Docket No. LPTF06
US App. No. 10/510,195

REMARKS**Status of the Application**

FIG. 6

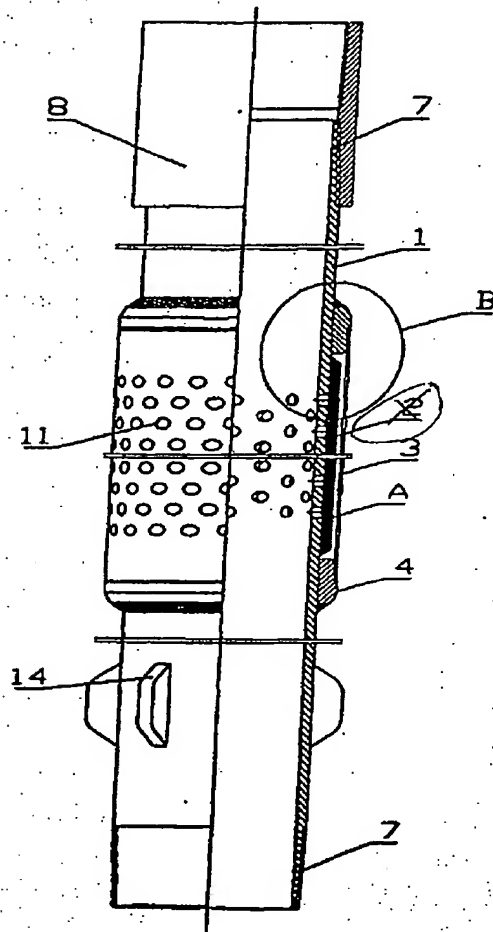
The drawings were objected to for including reference number 2 in Fig. 6 that is not described in the specification.

Applicant has amended Fig. 6 to delete reference number 2.
